Addendum Number Two
To The Drawings and Specifications for
Sedgwick County **Juvenile Residential Facility**

HANNEY & ASSOCIATES ARCHITECTS
1726 South Hillside, Wichita, Kansas

You are hereby instructed to include in your bids the following changes and/or corrections to the Drawings and Specifications for the **Sedgwick County HVAC System Replacement for the Juvenile Residential Facility**, in Wichita, Kansas.

3.1 Sheet A1.4

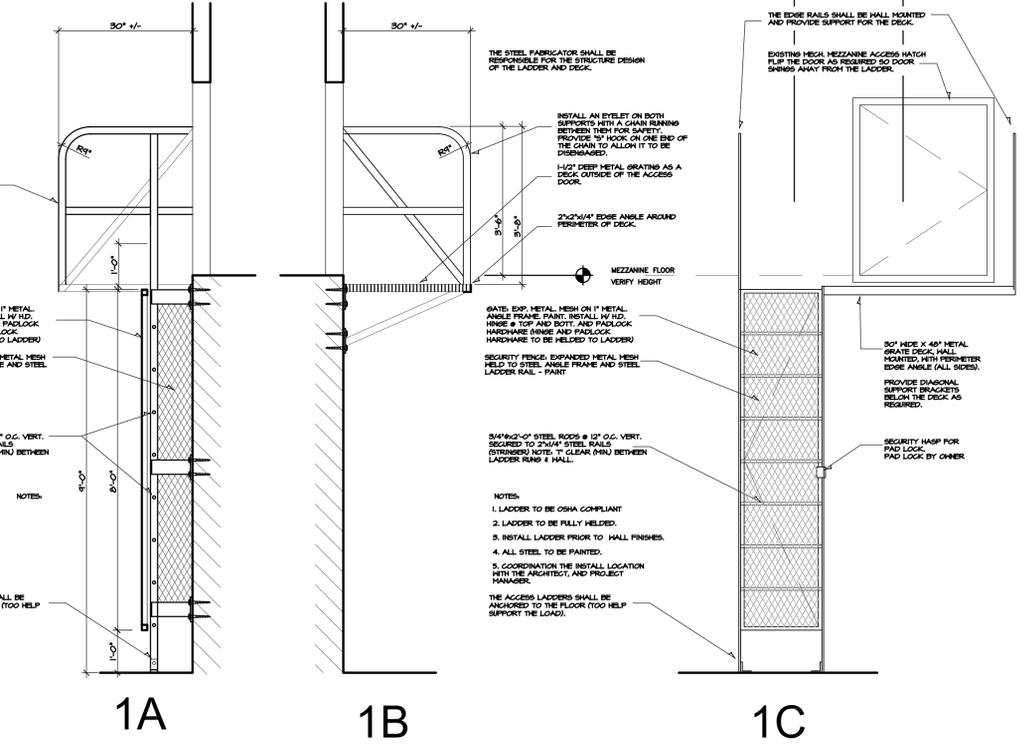
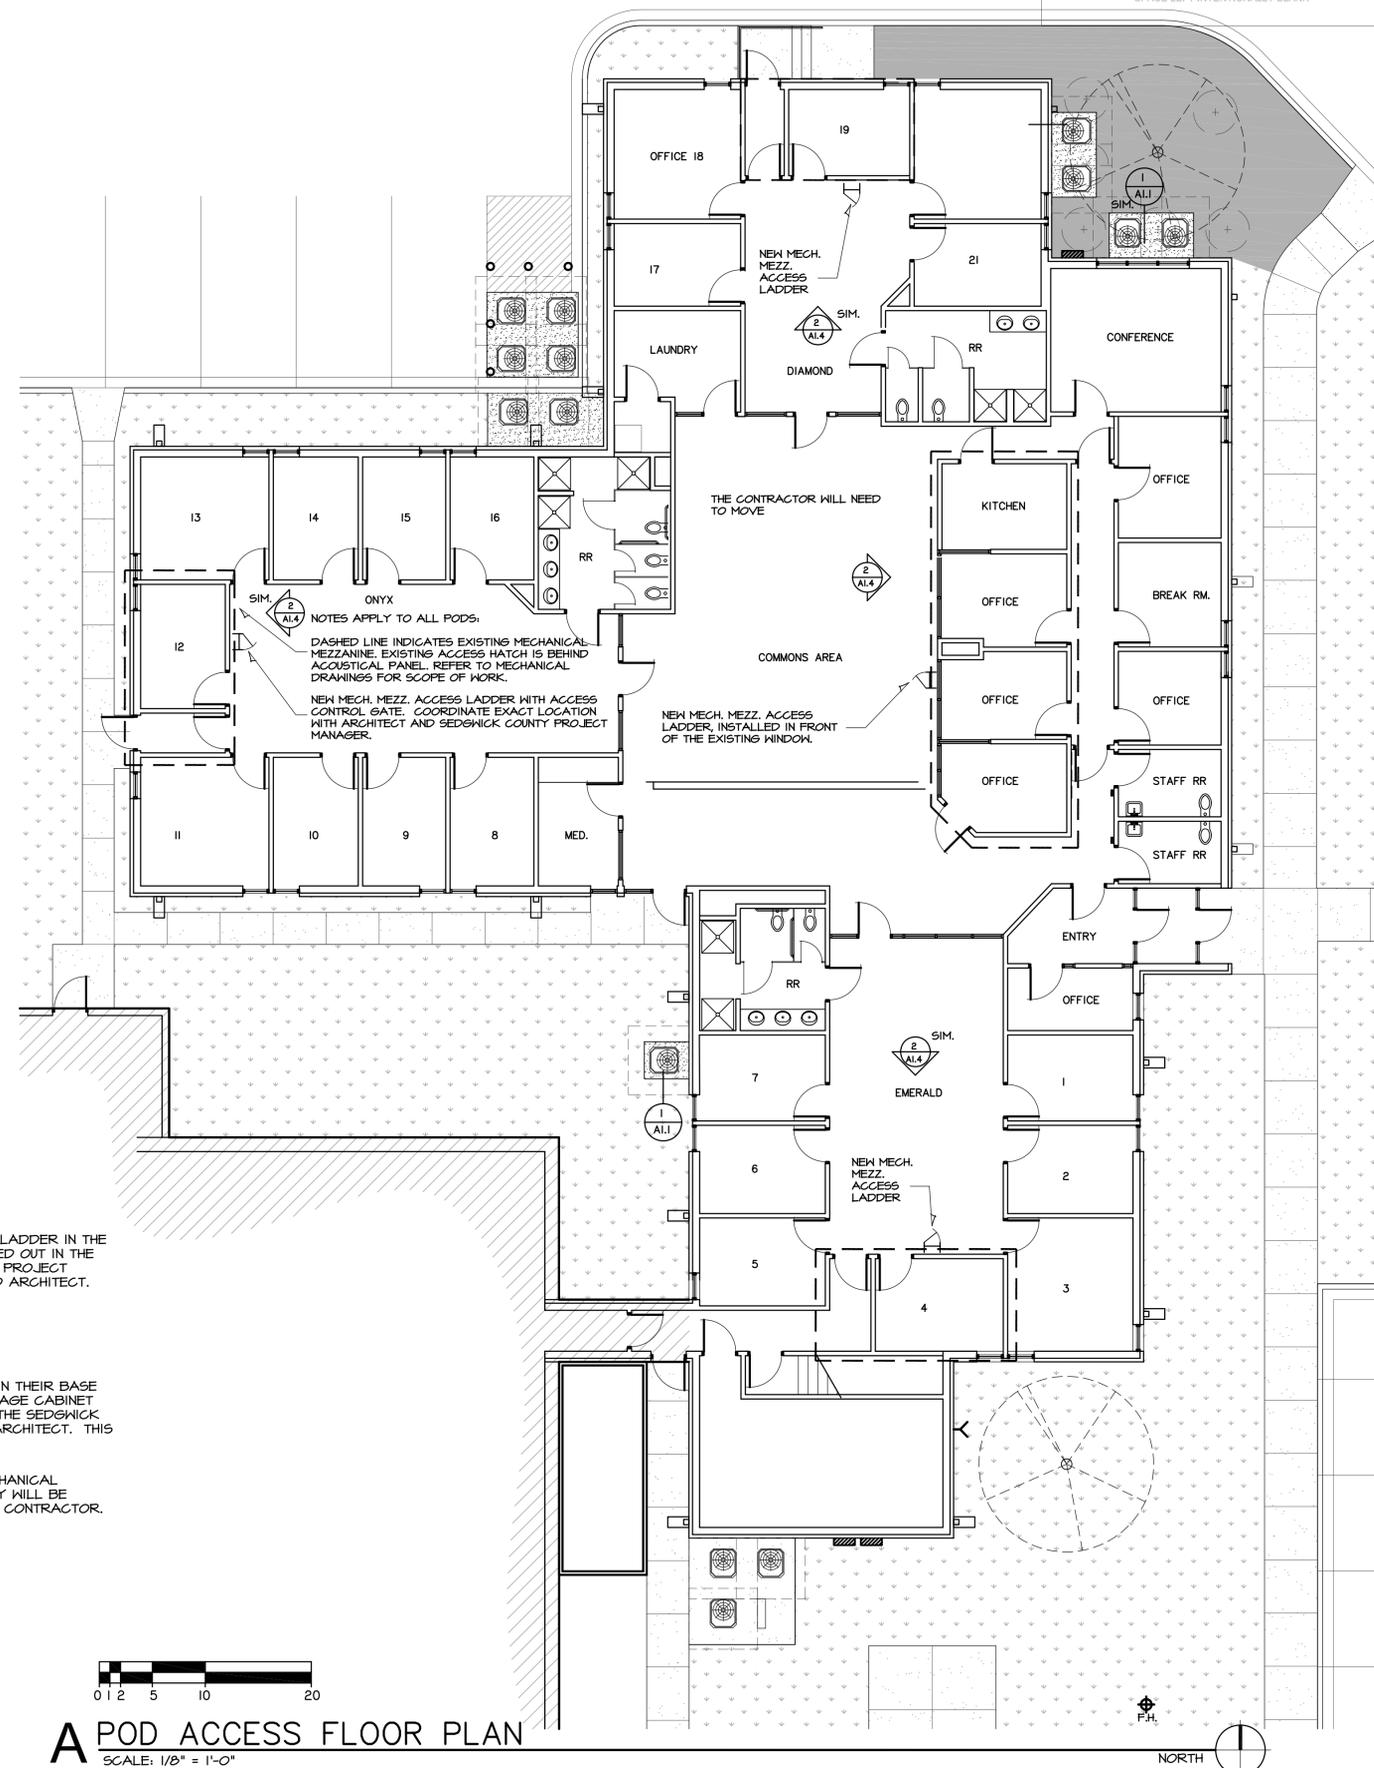
a. This sheet is new and is being issued with this addendum to address access to the mechanical mezzanines.

b. The steel fabricator shall be responsible for the structural engineering of the ladder and the deck.

c. The exact location and orientation(s) of each installation shall be coordinated in the field with the Sedgwick County Project Manager, Building Manager, and the Architect.

THE EXACT LOCATION OF THE NEW LADDER IN THE COMMONS WILL NEED TO BE WORKED OUT IN THE FIELD WITH THE SEDGWICK COUNTY PROJECT MANAGER, BUILDING MANAGER AND ARCHITECT.

THE CONTRACTOR SHALL INCLUDE IN THEIR BASE THE COST TO RELOCATE THE STORAGE CABINET TO A LOCATION AS DIRECTED BY THE SEDGWICK COUNTY PROJECT MANAGER AND ARCHITECT. THIS CONDITION EXISTS IN THREE PODS.

THERE WILL BE (4) NEW STEEL MECHANICAL MEZZANINE ACCESS LADDERS; THEY WILL BE PROVIDED AND INSTALLED BY THE CONTRACTOR.
